**RESPONSE TO
PLANNING
OBSERVATIONS**

**PROPOSED
REDEVELOPMENT**

**10 CHRISTCHURCH
HILL, HAMPSTEAD
LONDON NW3**

November 2014

Spring and Autumn Equinox

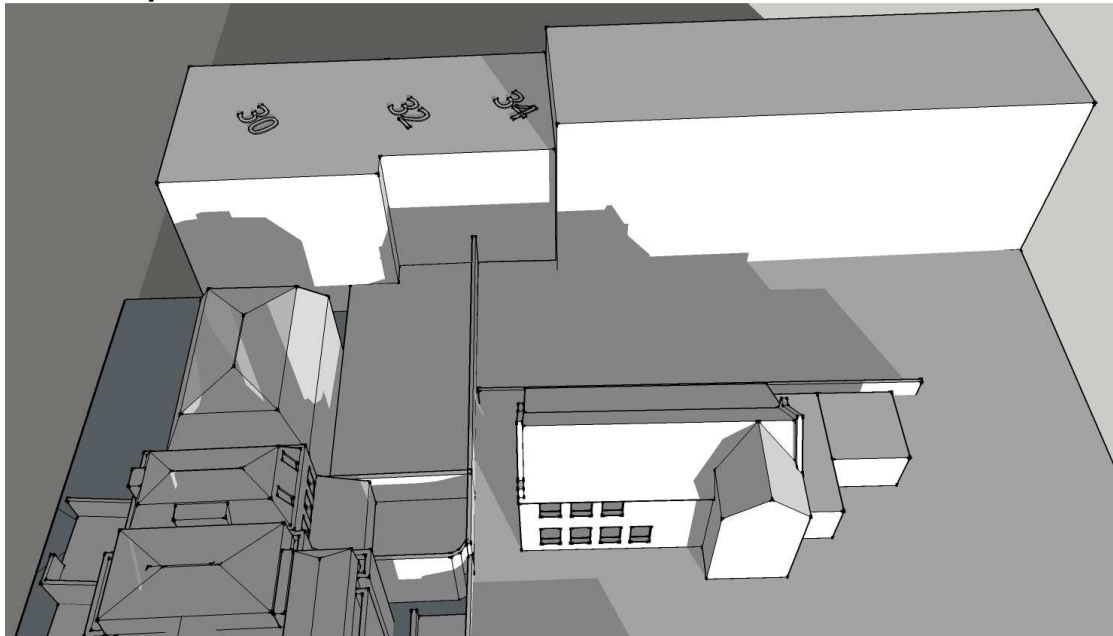
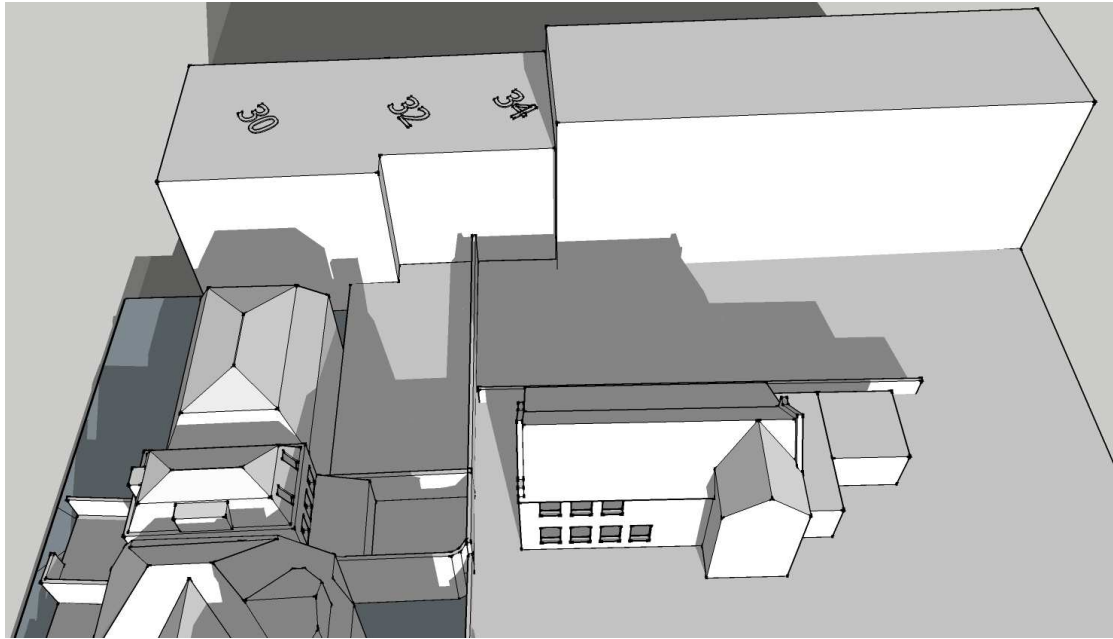
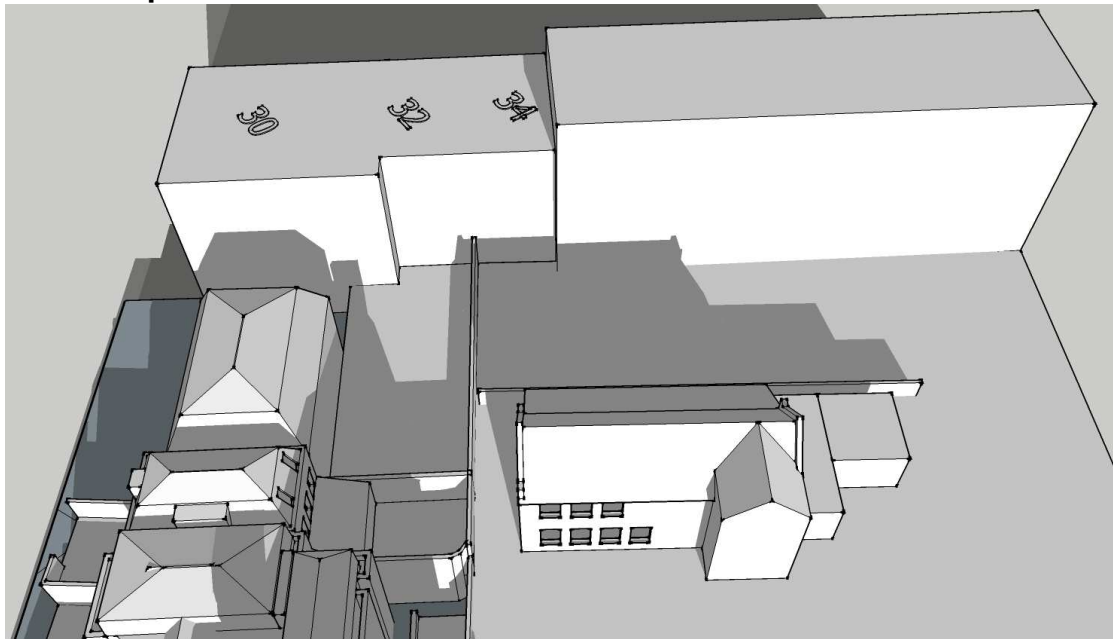
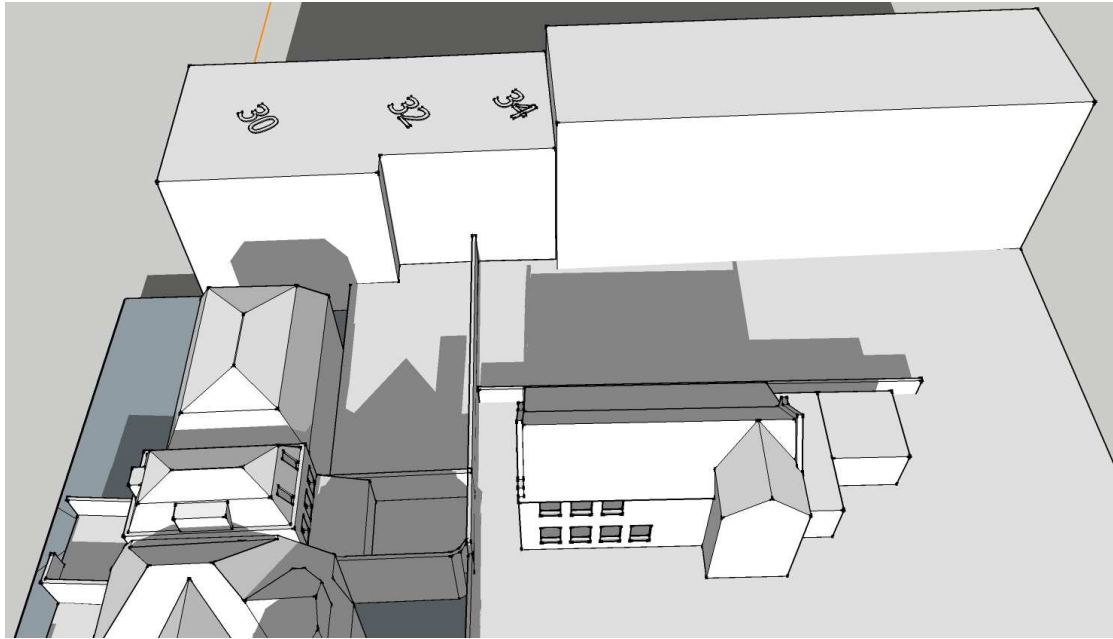
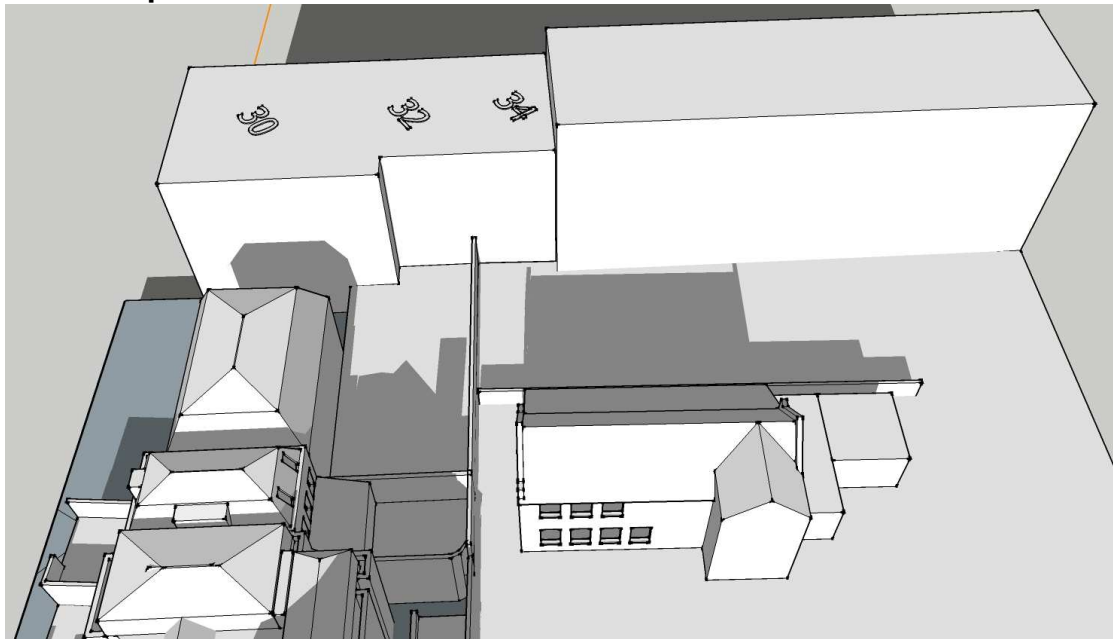
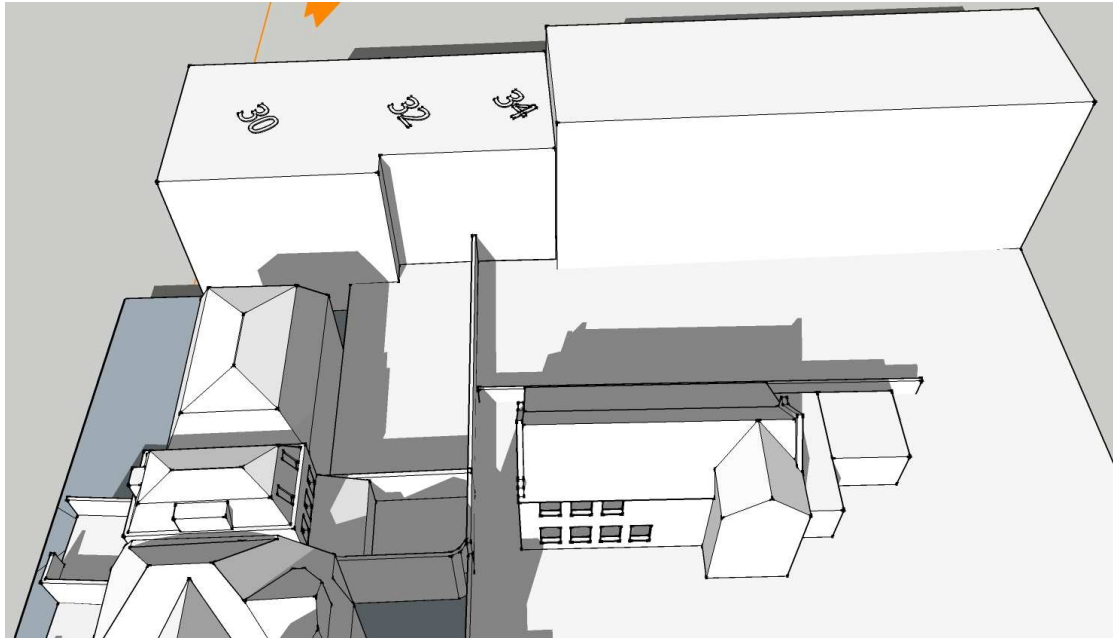
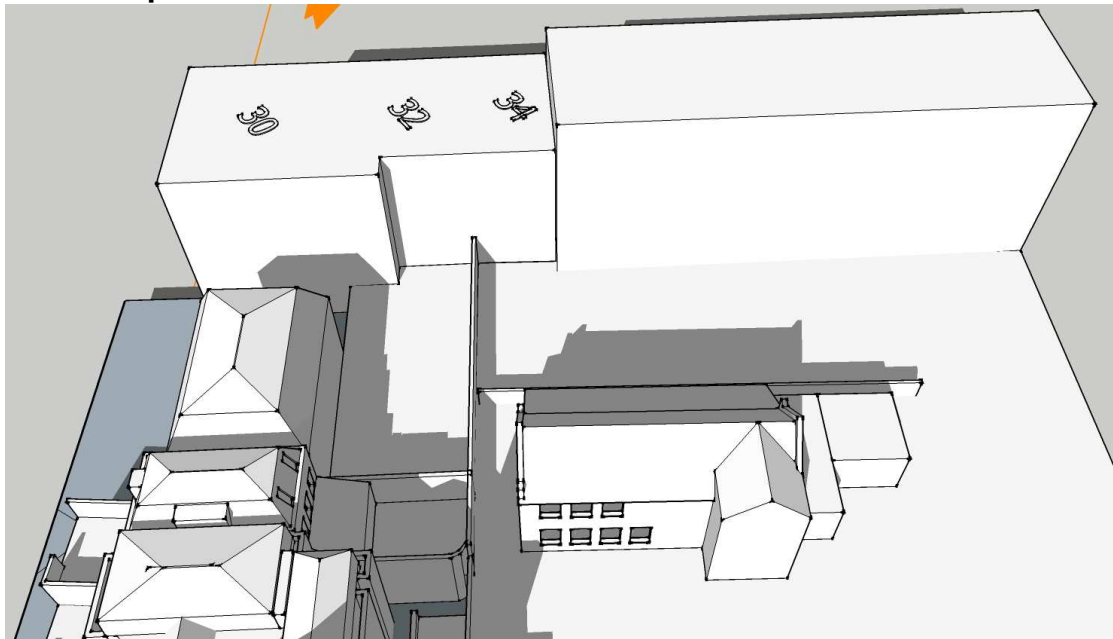
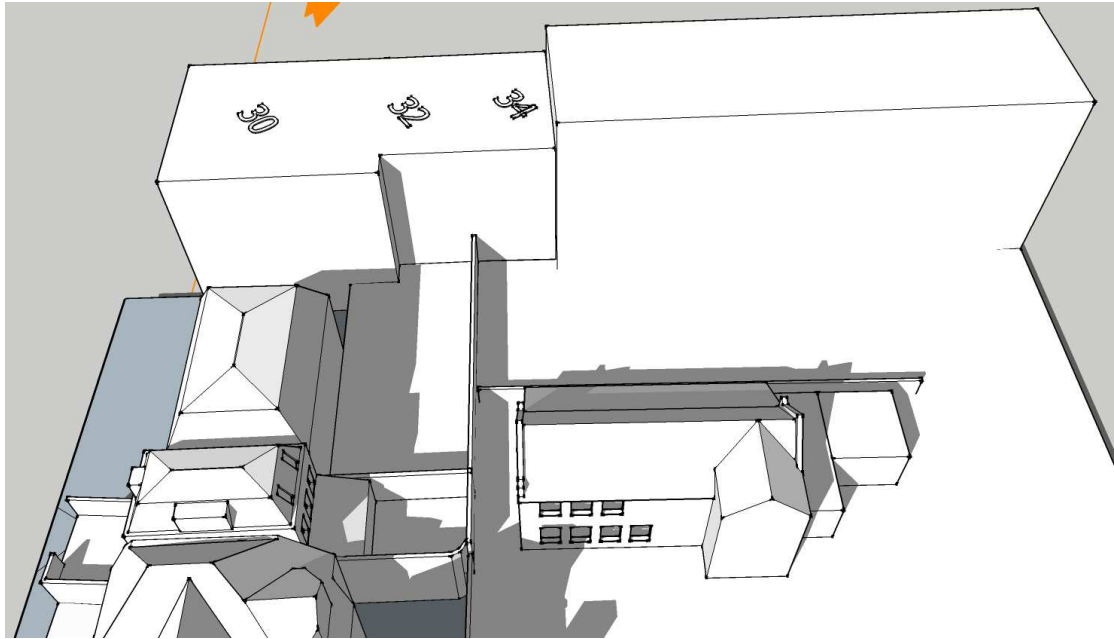
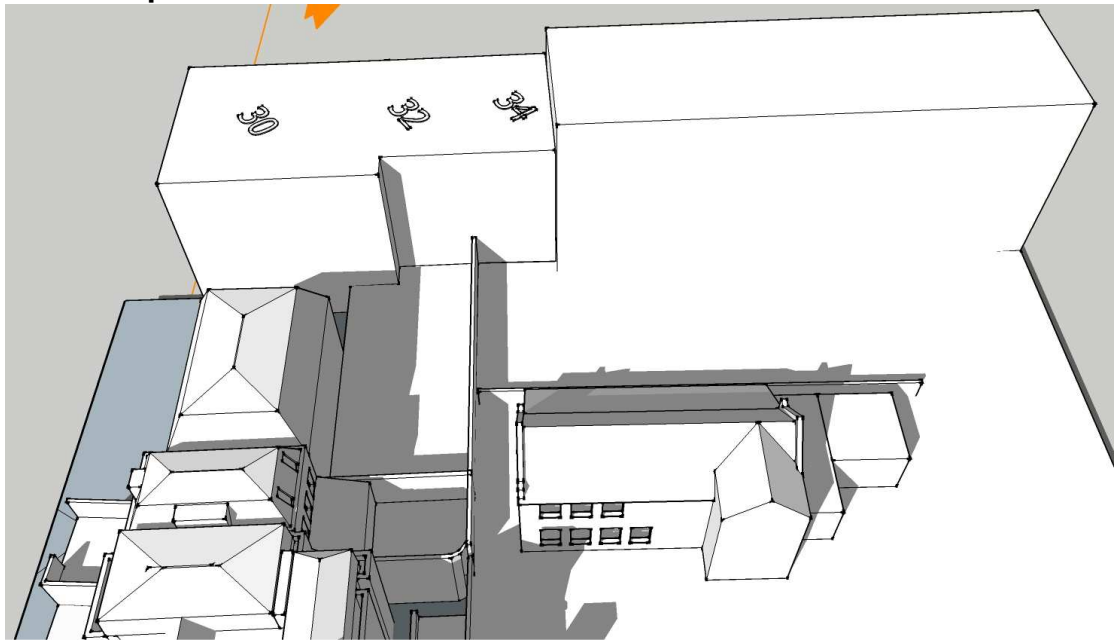
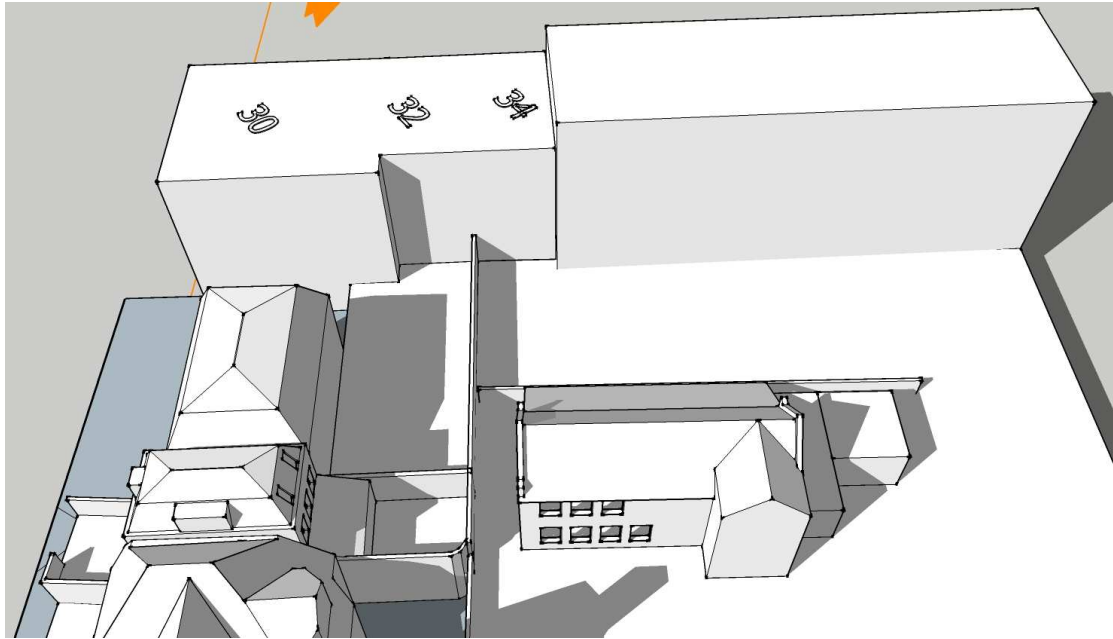
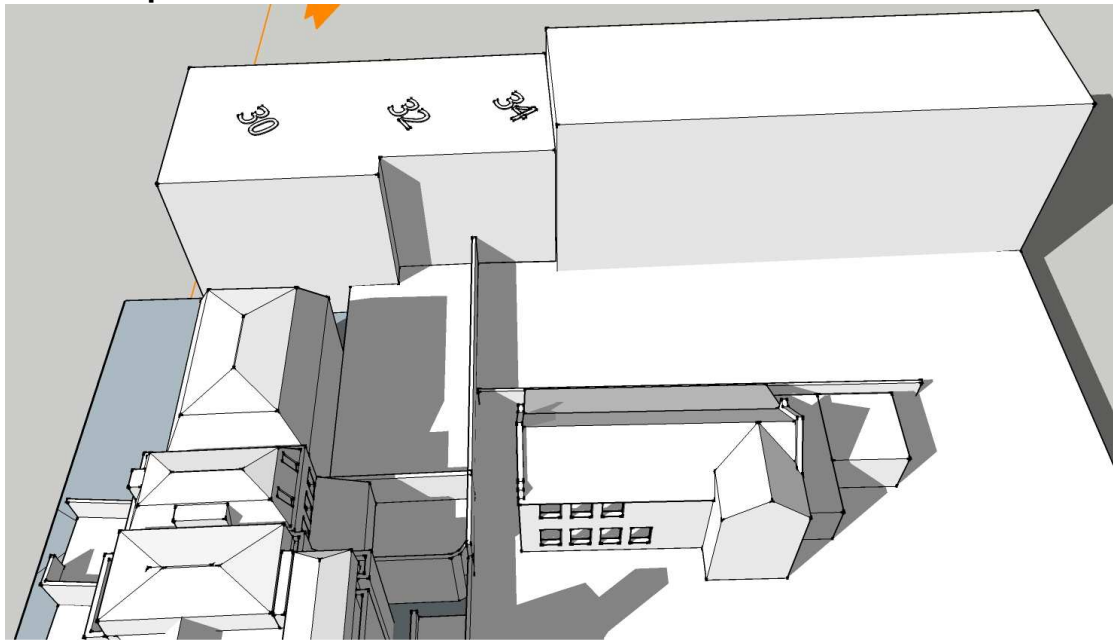
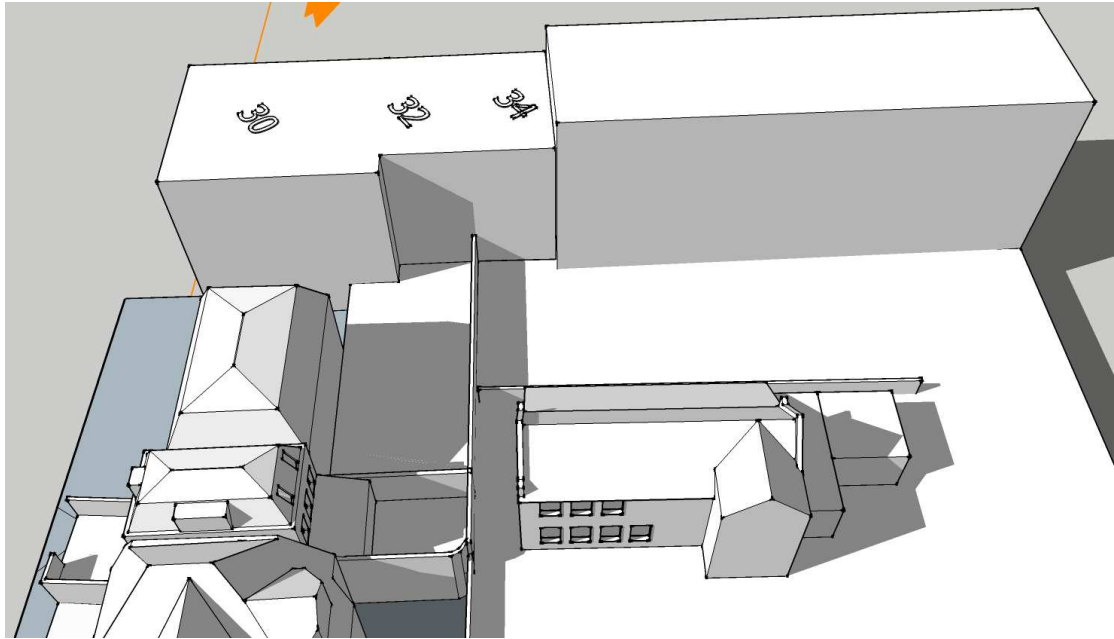
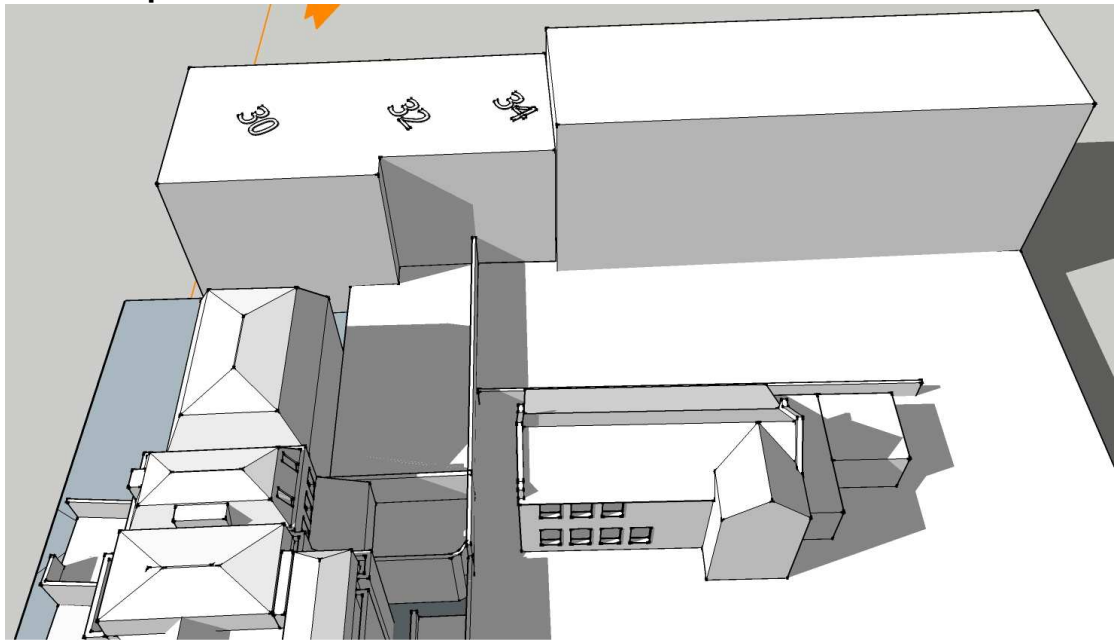
- The proposed development with its higher roofline which continues for a longer length (perpendicular to Christchurch Hill) and is also wider (parallel to Christchurch Hill), will impact the light at the back of 34 Well Walk, both in respect of the rear ground floor windows and also the patio, and will be especially acute during the Autumn to Spring months when the sun is lower and natural sun light is already somewhat limited. The Daylight & Sunlight Report submitted for this application is at a time of year which seems to drastically underestimate the effect of the proposed building given the sun is much higher in the sky in the period analysed vs. the Autumn to Spring months.
- The proposals will impact on light levels on the front gardens of nos. 13 and 14 Gainsborough Gardens and the rear gardens of 11, 12 and 13 of the same street.

As regards 34 Well Walk, it is averred that our analysis was made at an adjusted time of year to improve the apparent effects on the rear of this building and “to drastically underestimate the effect of the proposed building”. This is not the case as the initial shadow diagrams were compiled for the Equinox (21st March and 21 September). In response to this allegation, however, we have compiled proposed and existing analyses of the situation at the rear of 34 Well Walk at hourly rather than two-hourly intervals and at the Equinox, Midsummer’s Day (21st June) and Midwinter’s Day (21st December). These are set out below.

As can be seen from these images, there is no effect whatever on the sunshine reaching the rear of 34 Well Walk or its patio caused by the proposals on either Equinox nor Midwinter’s Day nor Midsummer’s Day. The assertion made is, therefore, without any foundation whatever and our original report does not underestimate the effects, drastically or otherwise, of the proposed building.
